E3649A-04D

S E R V I C E N O T E

E3649A DC Power Supply

Metal Strap Kit for tightening loose bumper and for fitting rear lock link in side-by-side rack mounting

Figure 2: Top view 3mm gap observed between two different chassis designs

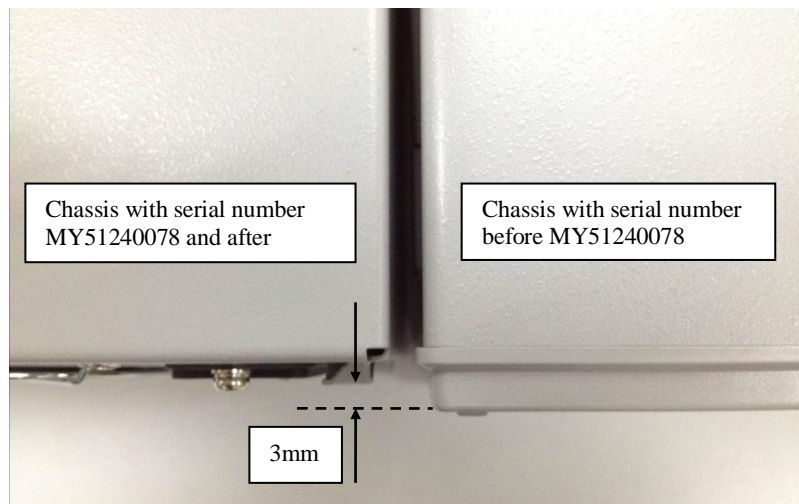
The chassis depth difference between the two designs is 3mm as shown in Table 1 and Figure 2 below.

Figure 3: Top view 3mm gap observed on rear lock link for side-by-side rack mounting

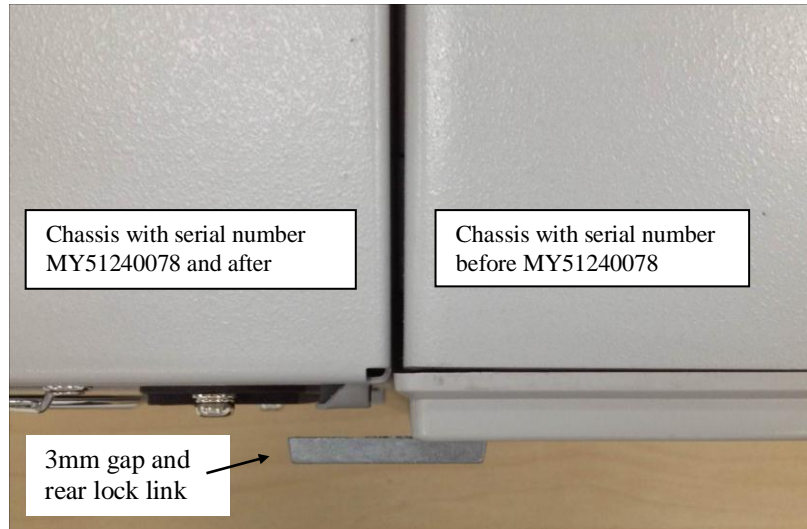
The 3 mm gap between the two different chassis may cause difficulties in securing them together using a rear lock link kit (part number 0050-2167) for side-by-side rack mounting as shown in Figure 3 below.

Solution for Situation 2

Use metal strap (part number E3631-07901), and stack the provided two metal straps together to form 3mm thickness and secure it with the provided screws on the rear lock link as shown in Figure 5 below.
